RE: 5 Dartmouth Square, Dublin 6.

I refer to the above property and to our application under s.5 of the Planning and Development Act 2000 for an exemption in respect of proposed works to our house.

Application Number	0354/19
Registration Date	31-Jul-2019
Decision Date	27-Aug-2019
Decision Order No.	P4772
Location	5, Dartmouth Square, Dublin 6
Proposal	EXPP: PROTECTED STRUCTURE: 1. The refurbishment of the 4 existing windows to the front of the house at the main entrance (ground floor) level and the first floor level. 2. The refurbishment of the 3 existing windows to the rear of the house at the main entrance (ground floor) level and the first floor and attic levels, including repairs and/o renewal of the patent reveals. 3. The fitting of draught restricting weather seals to the windows described in 1 or 2 above to improve comfort, thermal performance and reduce energy consumption. 4. The fitting of restrictors to the windows described in 1 and 2 above to improve safety. 5 Re-landscaping the front garden, without making any changes or works to the existing railings; to provide a gently sloping path to the lower ground level for baby buggies and bicycles.

Partial Site Plan, Front Garden - PROPOSED

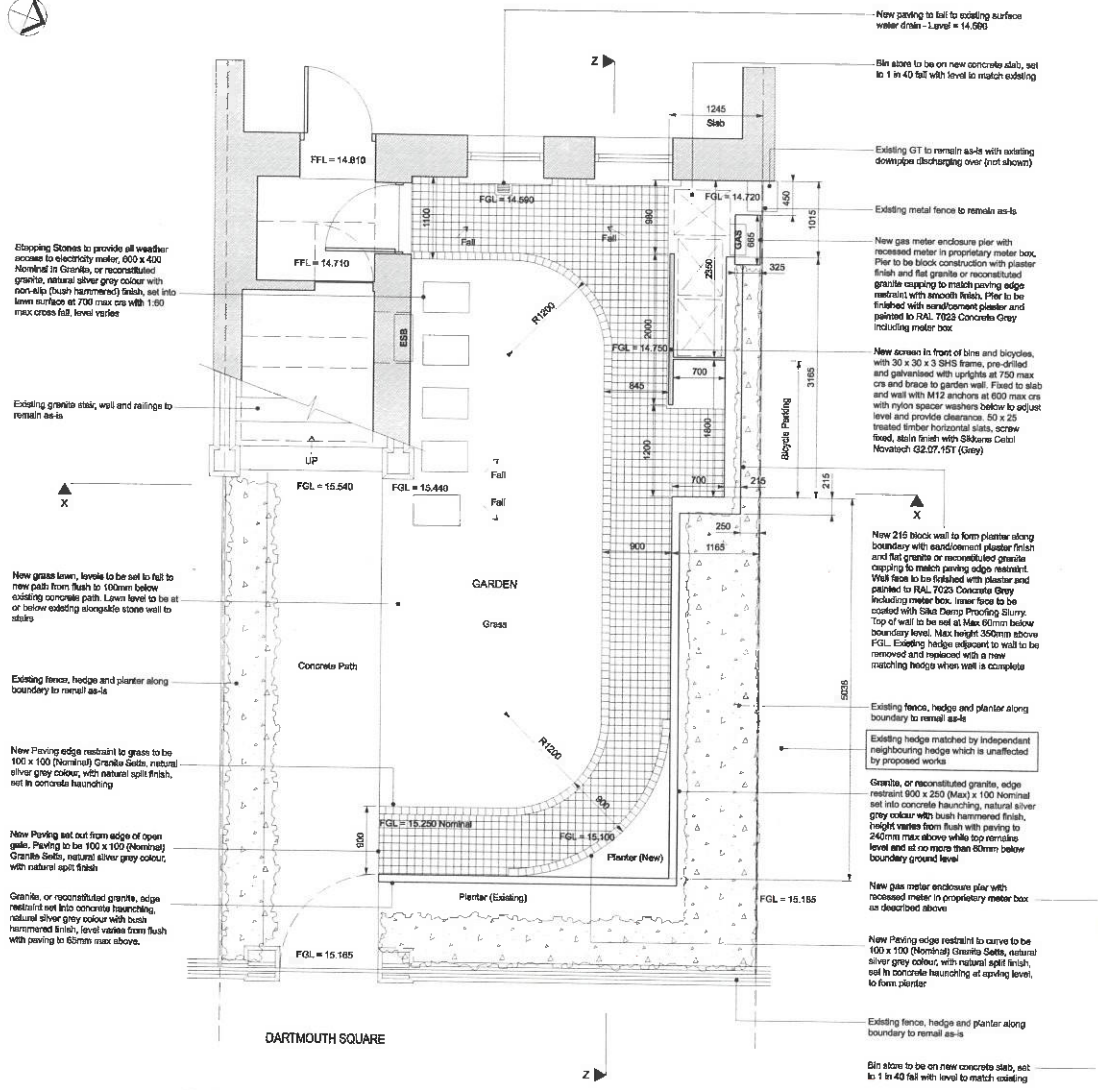
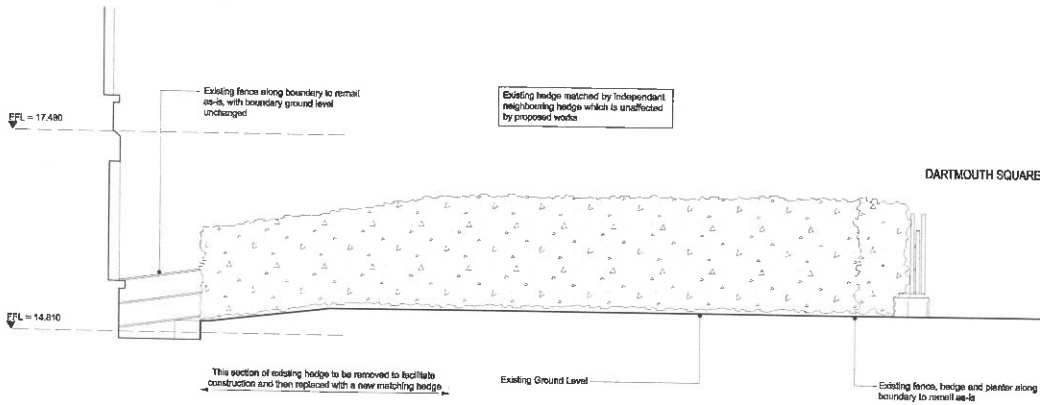
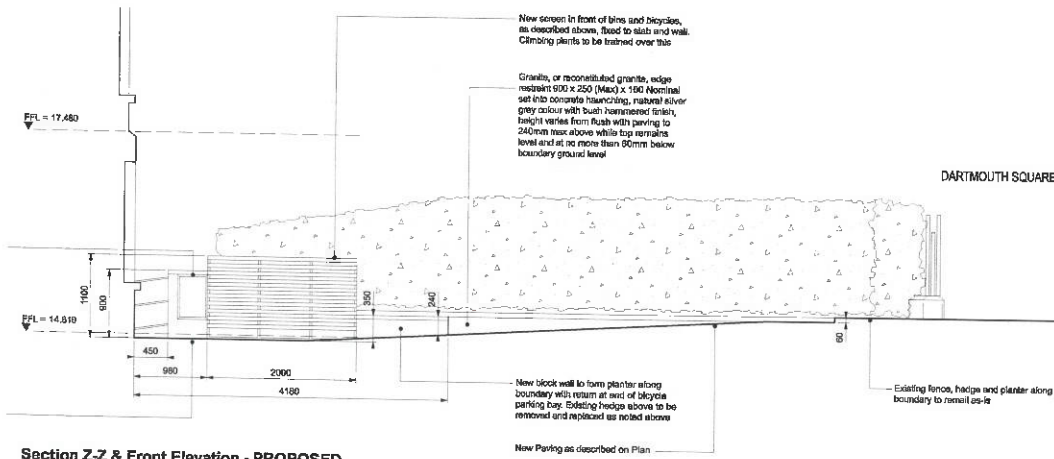
The applicant is requested to provide details on the height/depth/length of the proposed wall along the northern boundary, an elevation drawing showing its height in relation to the front façade of the house and the material to be used in its construction. This information is to include any proposal for a perpendicular wall at its eastern end.

The applicant is requested to provide section drawings showing the alteration to the slope of the garden across both the grass and the new path to assess whether this will have an impact on the protected structure, particularly within the context of the surrounding gardens. These should be dimensioned so that the impact can be fully assessed.

The applicant is requested to submit full details on the colour texture and nature of the material to be used for the path in order for the impact of this on the protected structure to be assessed.

- *Details on the height/depth/length of the proposed wall along the northern boundary* – Heights, depths and length are noted and comprehensively dimensioned on the drawings. Note that the wall is at least 250mm from the existing boundary fence and the top of the wall is no more than 350mm above finished ground level and typically 60mm below the ground level at the boundary.

- *An elevation drawing showing its height in relation to the front facade of the house and the material to be used in its construction* – Sections x-x and y-y on the drawings include elevations that show the proposed low wall in relation to the front facade of the house, and the construction is noted on the Plan

- *This information is to include any proposal for a perpendicular wall at its eastern end* – The wall is only 3380mm long and there's a short return 700mm long at the eastern end and this is 240mm above finished ground level and typically 60mm below the ground level at the boundary.

- *Provide section drawings showing the alteration to the slope of the garden across both the grass and the new path and these should be dimensioned* – Two sections labelled x-x and y-y are provided and both are dimensioned

- *Submit full details on the colour texture and nature of the material to be used for the path* – The Paving material for the path is to be 100 x 100 (Nominal) Granite Setts, natural silver grey colour, with natural split finish

Partial Site Plan, Front Garden - PROPOSED

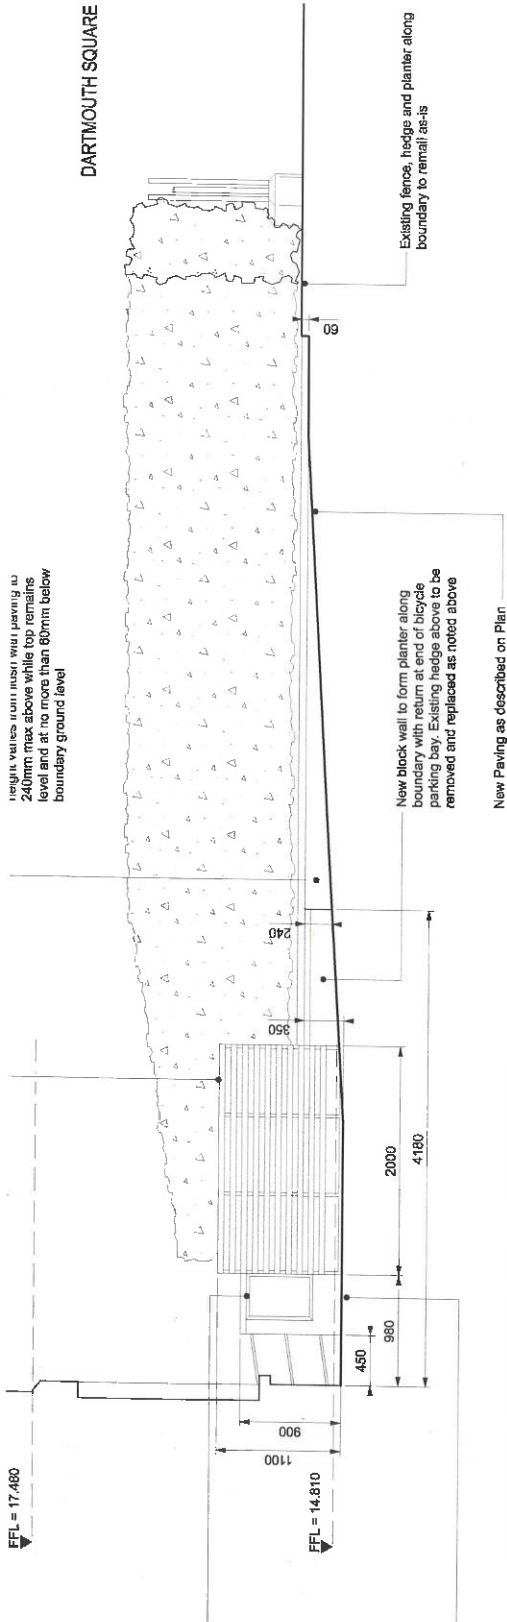
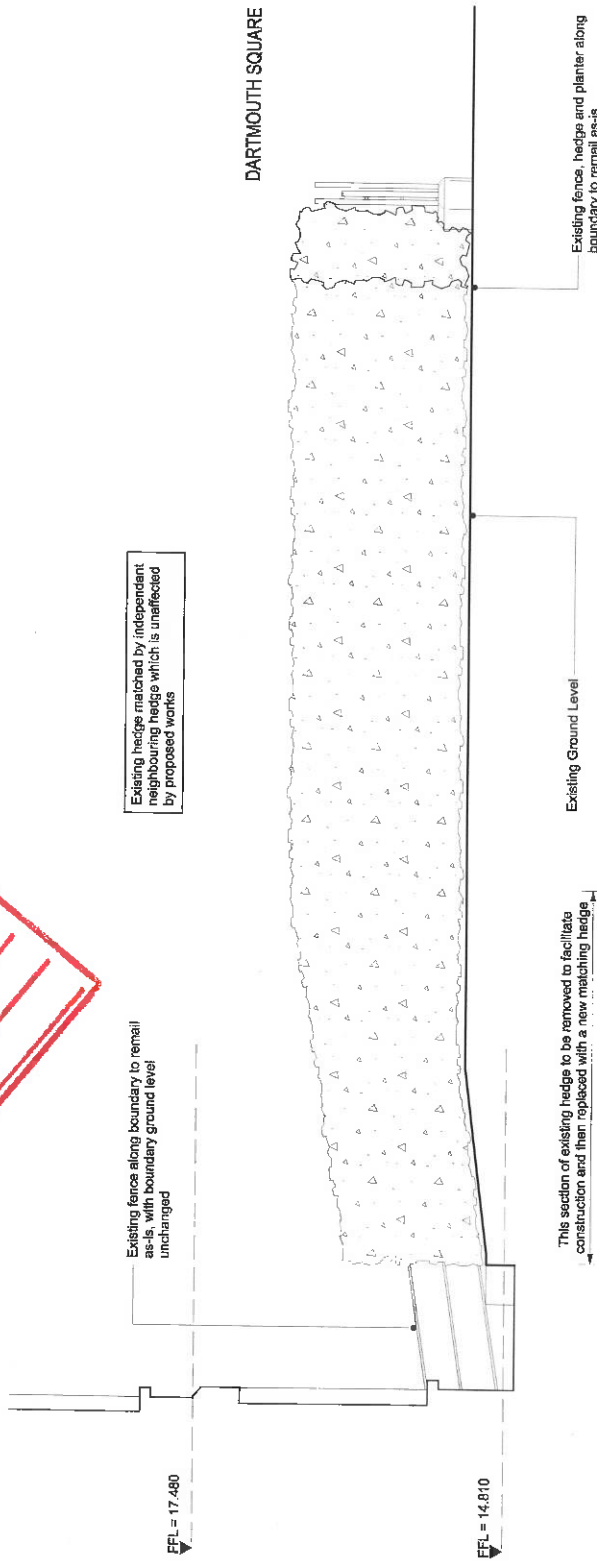
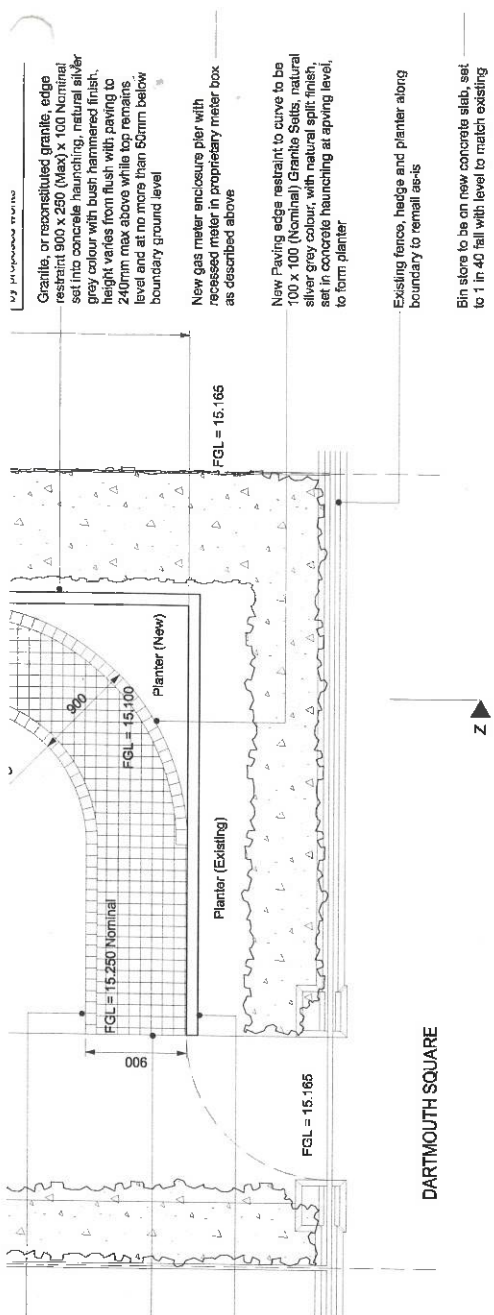
Note: The landscaping works proposed include the provision of a bin store/bicycle storage area, gas meter enclosure, sloping pathway and increased hard landscaping as shown on Drawings 1808-S5-2.1.0 and 1808-S5-2.1.1. The cumulative effect of the proposed interventions to the front garden of the protected structure would materially affect its character and cannot be considered exempted development.

- New screen in front of bins and bicycles, as described above, fixed to slab and wall. Climbing plants to be trained over this.
- Granite, or reconstituted granite, edge restraint 900 x 250 (Max) x 100 Nominal set into concrete haunching, natural silver grey colour with bush hammered finish.

New Paving edge restraint to grass to be 100 x 100 (Nominal) Granite Setts, natural silver grey colour, with natural split finish, set in concrete haunching

New Paving set out from edge of open gate. Paving to be 100 x 100 (Nominal) Granite Setts, natural silver grey colour, with natural split finish

New gas meter enclosure pier with recessed meter in proprietary meter box as described above

Bin store to be on new concrete slab, set to 1 in 40 fall with level to match existing
